CITY OF ALBUQUERQUE

**RE: Lot 7 Block 1 Unit 5 Volcano Cliffs SAD 227
6623 Rimrock NW
Grading and Drainage Plan
Engineers Stamp Date 9/8/17 (D10D010)
Pad Certification Dated 9/20/17**

Based upon the information provided in your submittal received 9/20/17, this plan is approved for Building Permit.

ENGINEER'S SEAL		6623 RIM ROCK		DRAWN BY WCUJ
		GRADING AND DRAINAGE PLAN		DATE 9-07-17
				21795-LAYOUT-9-07-17
		 <i>Rio Grande Engineering</i> 1606 CENTRAL AVENUE SE ALBUQUERQUE, NM 87106 (505) 872-0589	SHEET # —	
			JOB # 21795	
DAVID SOULE P.E. #14522		9/8/17

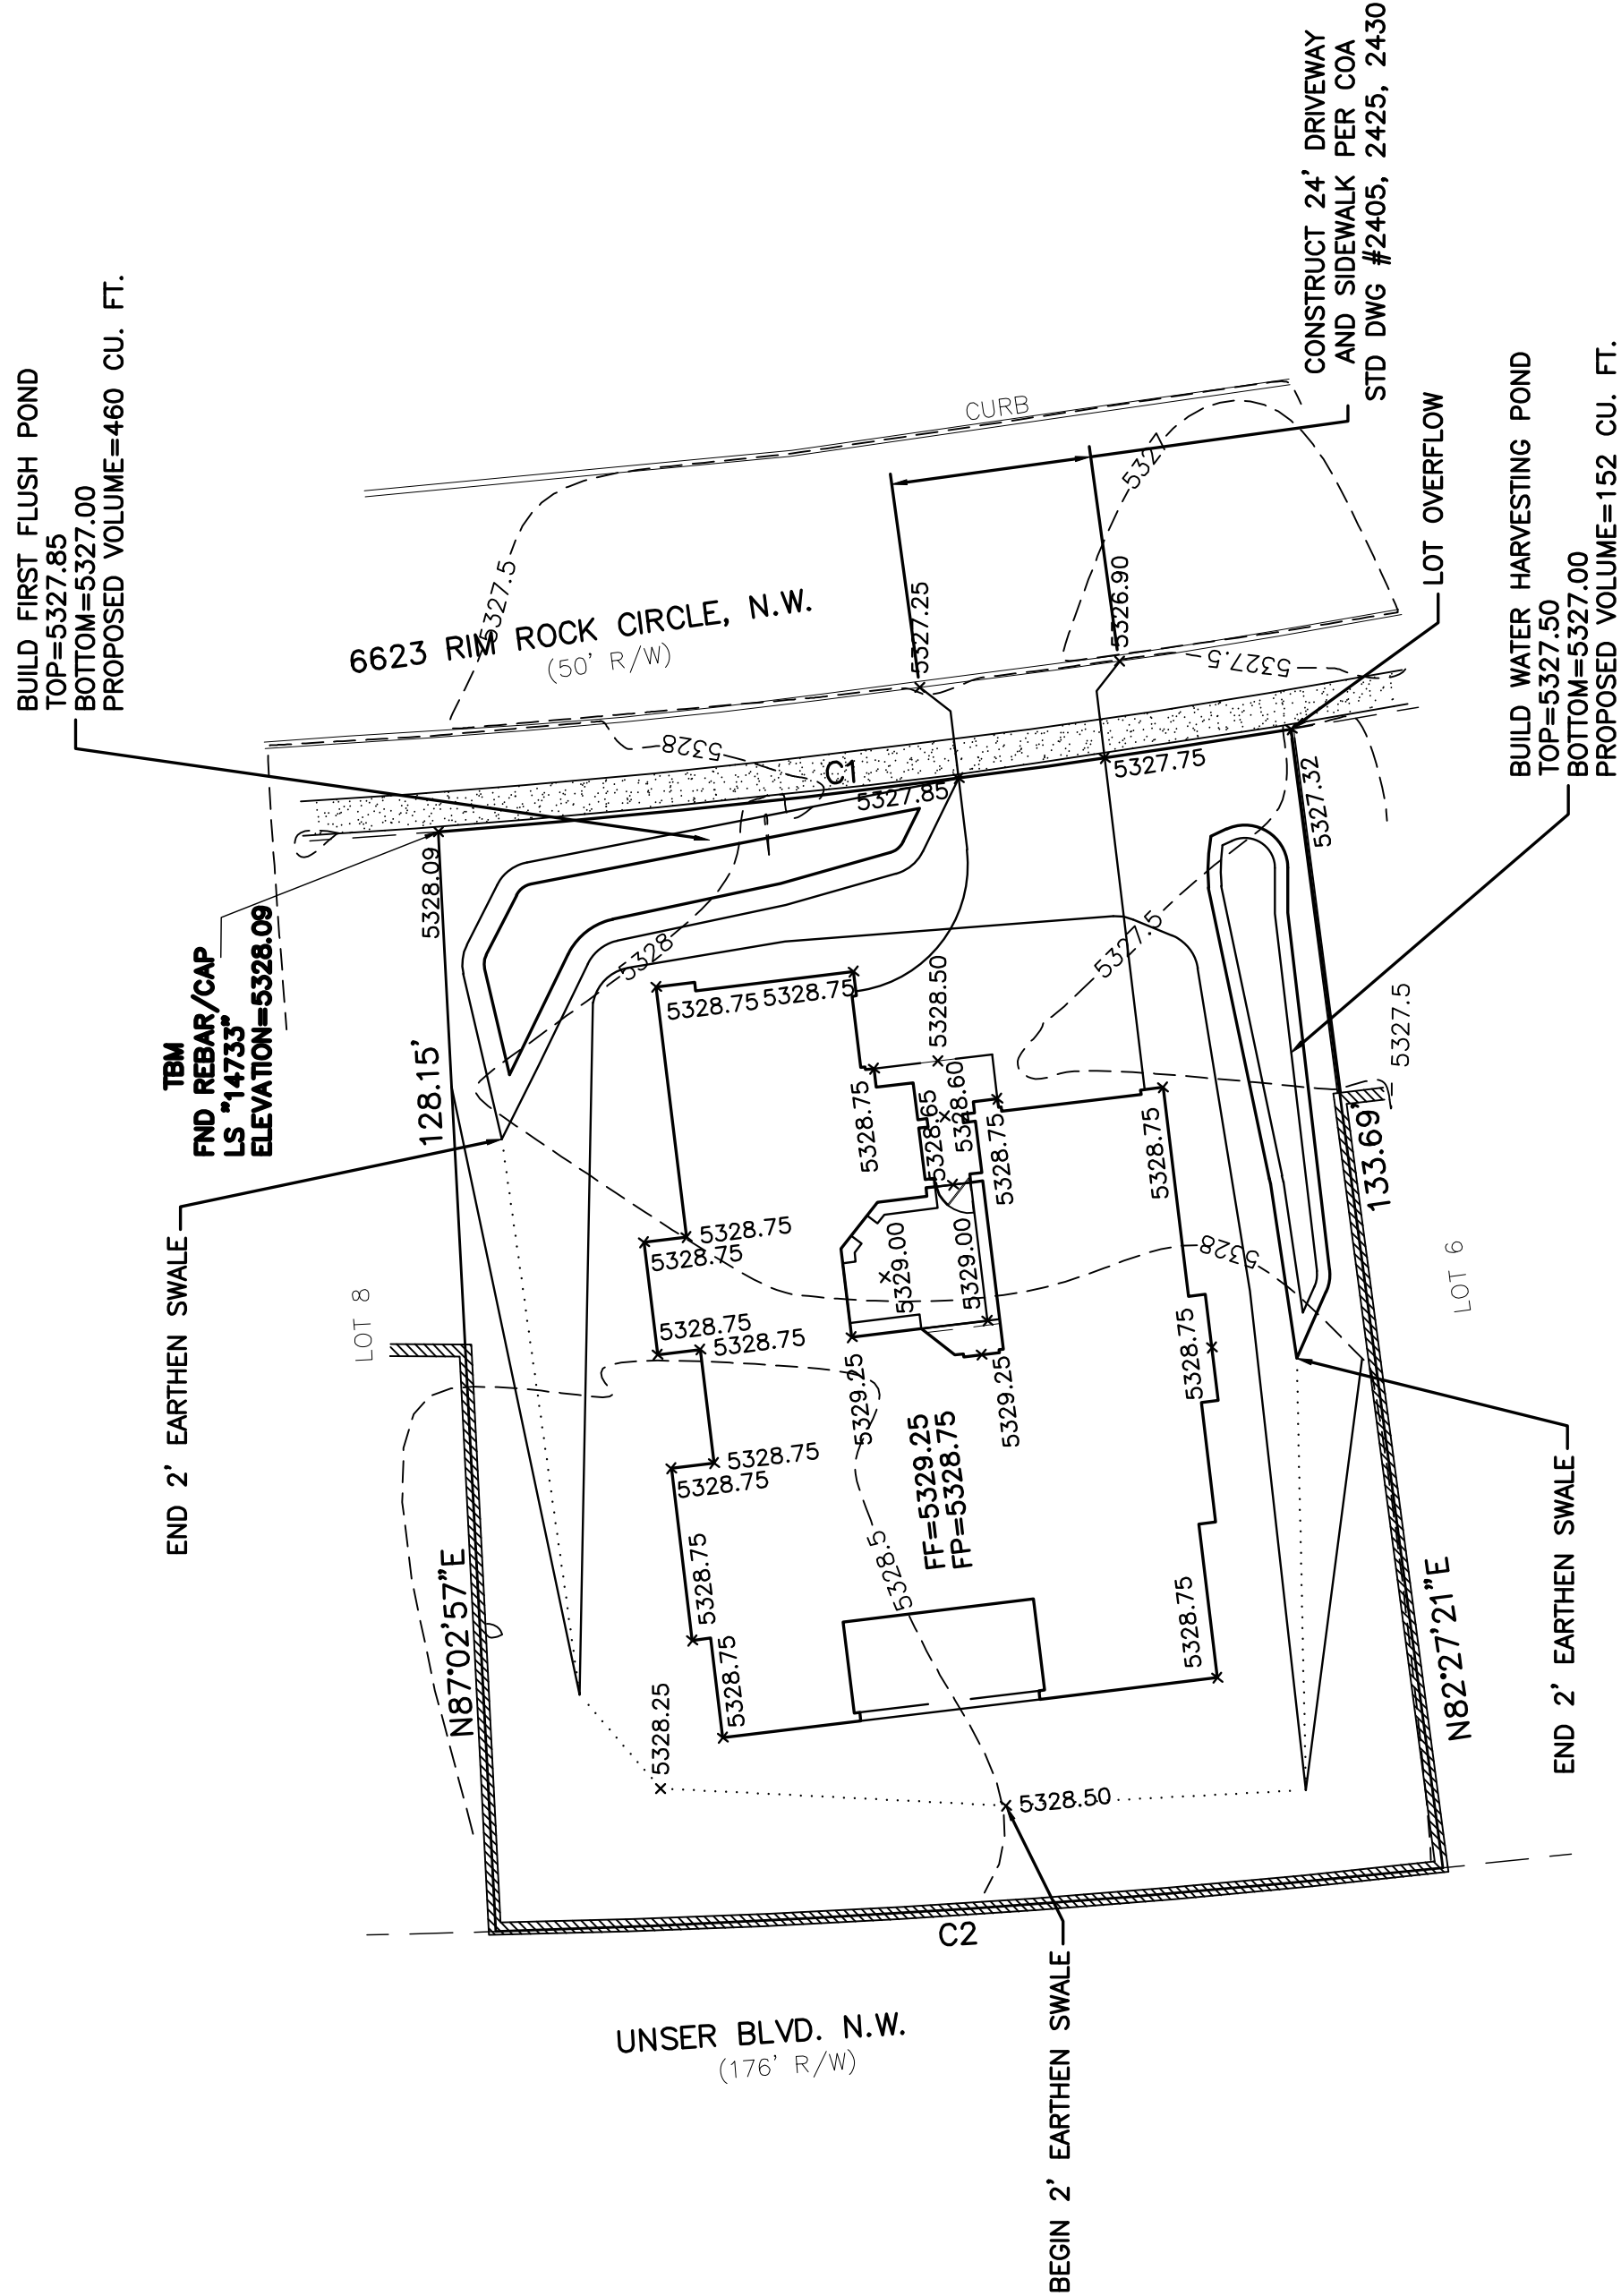
Please inform the builder to attach a copy of this approved plan to the construction sets in the permitting process prior to sign-off by Hydrology. Also, notify the owner/contractor that a separate permit for any fence is required, and this is the plan to be used for the placement of the fence.

Prior to Certificate of Occupancy release, Engineer Certification per the DPM checklist of this plan will be required.
